1958 Agreement:**Consideration of draft amendments to existing****UN Regulations submitted by GRSG****Proposal for Supplement 1 to the 03 series of amendments to
UN Regulation No. 58 (Rear underrun protection devices)****Submitted by the experts from the Working Party on General Safety***

Supplement 1 to the 03 series of amendments to UN Regulation No. 58 (Rear underrun protection devices)

Figure 1

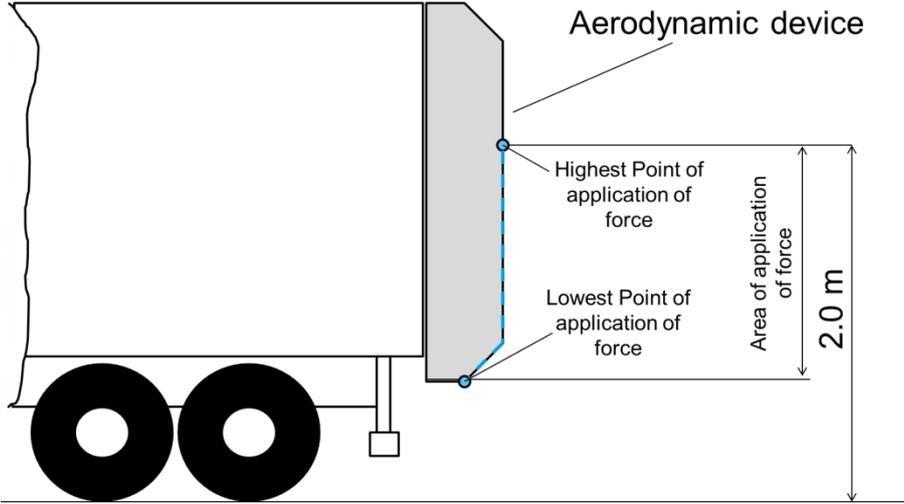
- 5.1.1. A force shall be applied parallel to the longitudinal axis of the vehicle via a surface not more than 250 mm in height and 200 mm wide with a radius of curvature of 5 ± 1 mm at the vertical edges or an adaptor. The surface or adaptor shall not be rigidly fixed to the aerodynamic device and shall be articulated in all directions. When the test is carried out on a vehicle the height of the centre of the surface or adaptor shall be defined by the manufacturer in an area between the lowest edge of the aerodynamic device and a point no more than 2.0 meters above the ground in vehicle-mounted condition (see figure 1). This point is to be defined on a laden vehicle with the technically permissible maximum laden mass.

Figure 2

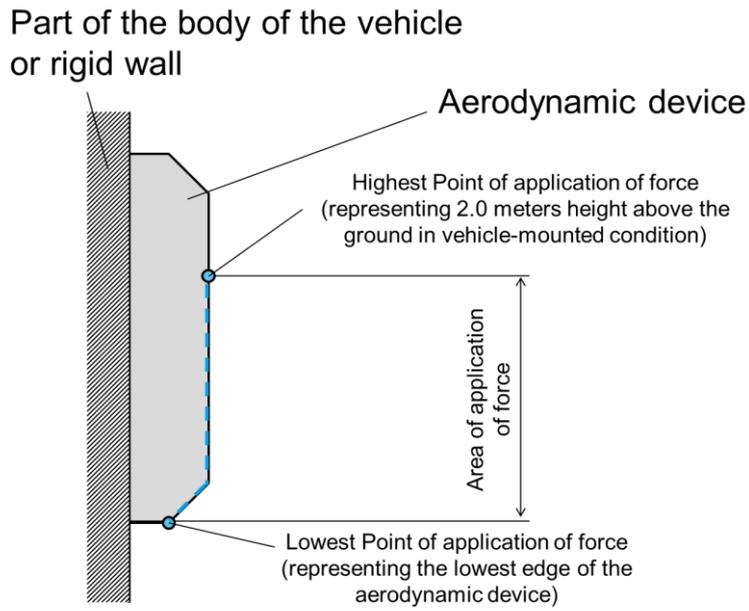
When the test is carried out on a part of the body of the vehicle type or on a rigid wall the height of the centre of the surface or adaptor shall be defined by the

manufacturer in an area between the lowest edge of the aerodynamic device and the point that represents the height of no more than 2.0 meters above the ground in vehicle-mounted condition on a laden vehicle with the technically permissible maximum laden mass (see figure 2).

Figure 3

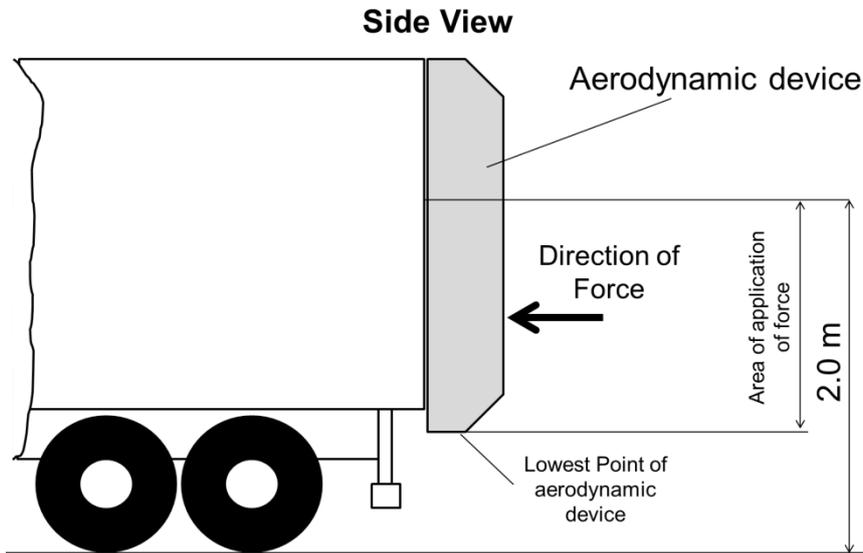
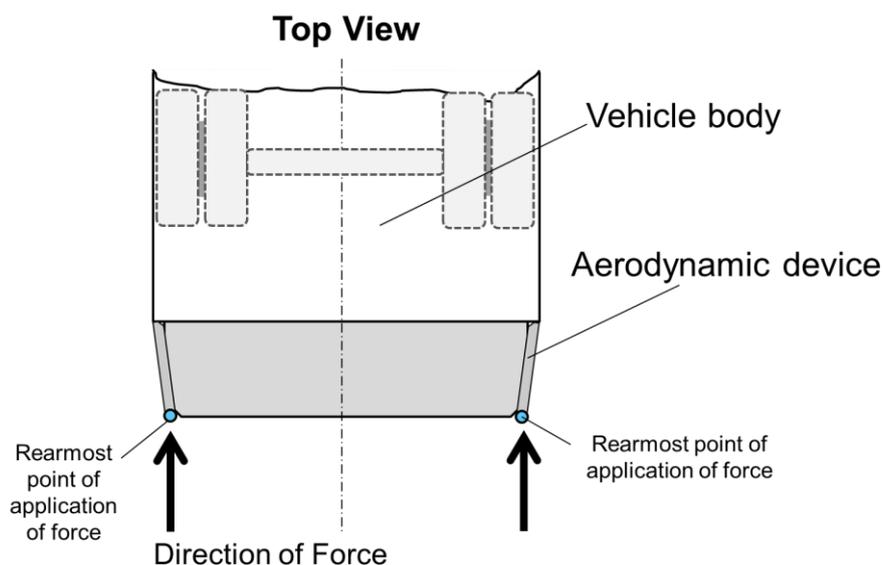
5.1.2. A horizontal force of maximum $4000\text{ N} \pm 400\text{ N}$ shall be applied consecutively to two points situated symmetrically about the centre line of the vehicle or the centre line of the device on the rearmost outer edge of the aerodynamic device in completely unfolded or not retracted condition (see figure 3). The order in which the forces are applied may be specified by the manufacturer.

Figure 4

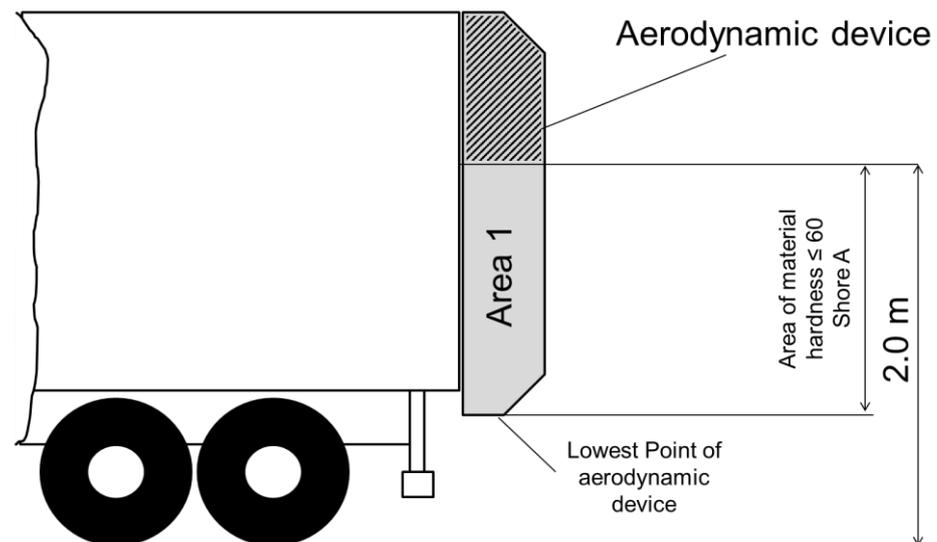
- 6.2. Notwithstanding the provisions in paragraph 5.1., 5.1.1., 5.1.2. and 6.1. the application of forces shall not be conducted if the aerodynamic device is made of a material of hardness not exceeding 60 shore A in the area 1 regarding figure 4. Components (fastenings, hinges, actuators, springs, cables, lamps, etc.) used to install the aerodynamic device on the body of the vehicle or that are mounted on the aerodynamic device are exempted from these provisions.
